Kawasaki Mule PRO-FXT C-Pillar Product Update Bulletin

For p/n's: 1KAPFXTCA & 1KAPFXTCAS1

Installed on PRO-FXT 1000 Models

Fig. 1.1 (Cut Right C-Pillar)

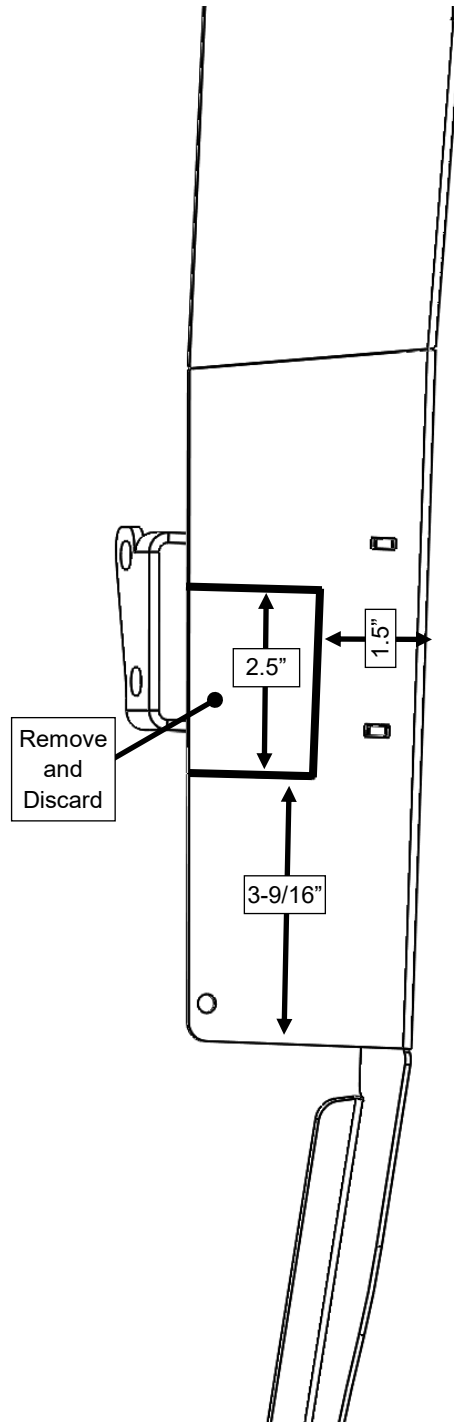
Issue: A new air intake bracket has been added to the right rear C-Pillar on the Pro-FXT 1000 vehicle that causes an interference with existing cabin C-Pillars.

Remedy: cut a piece out of the right cabin C-pillar to clear the bracket.

1.1 First, remove the bulb rubber from the edge of the right rear C-Pillar to reveal the area of sheet metal shown in Figure 1.1.

1.2 Mark out three lines using the dimensions shown in Figure 1.1.

1.3 Using a metal cutting saw, cut out the piece and discard.

1.4 Test fit the C-pillar onto the vehicle to ensure fitment over the bracket on the ROPS and enlarge the cutout if necessary.

1.5 Once satisfied with the fitment, apply black touch up paint to the cut sheet metal edge to prevent rust.

1.6 Continue to install the C-Pillar per step 6 in the manual, but re-install the rubber onto the edge of the part on the inside of the air intake bracket after the part is installed onto the vehicle so the rubber remains a continuous piece from top to bottom.
